Ford Conversion Flywheel with Kevlar® Pilot Bushing

This flywheel (part number 167323) includes a unique accessory that is designed to provide longer life and lasting durability.

Kevlar® Bushing

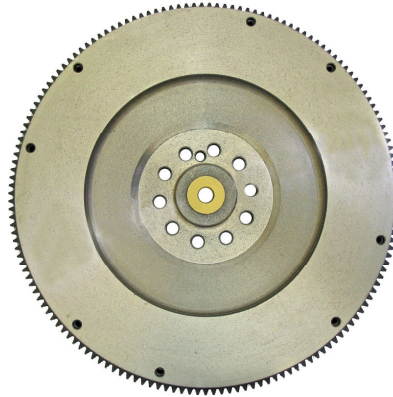
A Kevlar® bushing has been installed in this flywheel, replacing the needle-style bearing typically used in this application. That's because the needle bearing is prone to premature failure, resulting in transmission input shaft damage and subsequent clutch failure. The Kevlar® bushing provides two important advantages:

1. It will not fail in severe duty applications.
2. It will accept a scored transmission input shaft, as long as the transmission input shaft mating surface is "cleaned up" by removing irregularities and high spots associated with a prior needle bearing failure.

For those that insist on using only OEM replacement parts, an OEM needle bearing has been included with the matching clutch kit. To install the needle bearing, remove the Kevlar® bushing using the proper sized bushing-driver or a 7/8" deep wall socket with a ball peen hammer. Drive the Kevlar® bushing out from the engine side of the flywheel. Install the needle bearing in the reverse order.
